Q664NAS1

TECHNICAL BULLETIN

Service Action: Incorrect Bracket Fitted

MODEL:	MODEL YEAR:	VIN:	ASSEMBLY PLANT:	APPLICABILITY:
Range Rover Sport (LW)	2017	667482-671021	Solihull	V6 S/C 3.0L Petrol

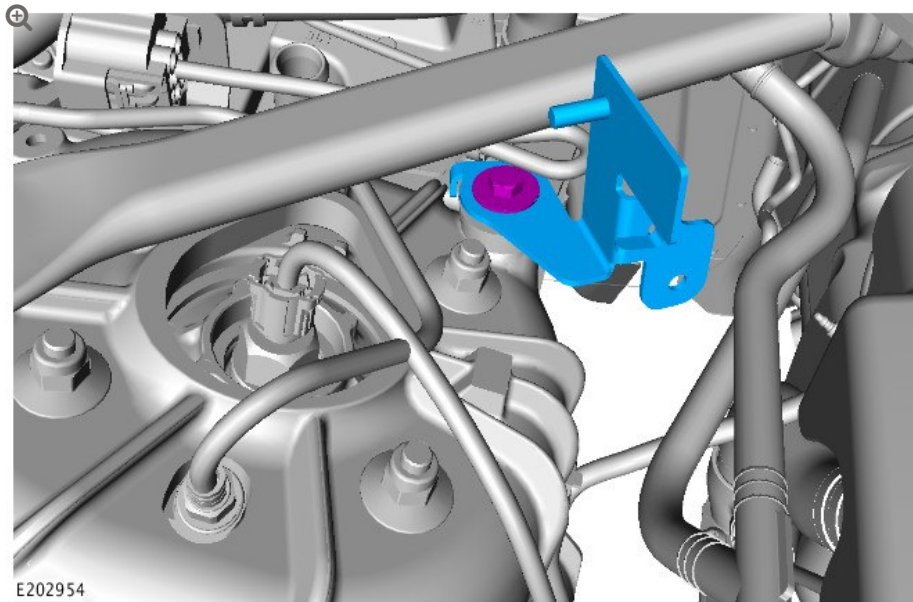
An issue has been identified on certain vehicles within the listed Affected Vehicle Range where a bracket may be fitted in the engine compartment in error. The bracket can come into contact with an underhood coolant hose which over time could chafe and ultimately wear through, leading to loss of coolant.

2 Inspect for unused bracket near the front right suspension top mount.

Remove the bolt and discard the unused bracket near the front right suspension top mount.
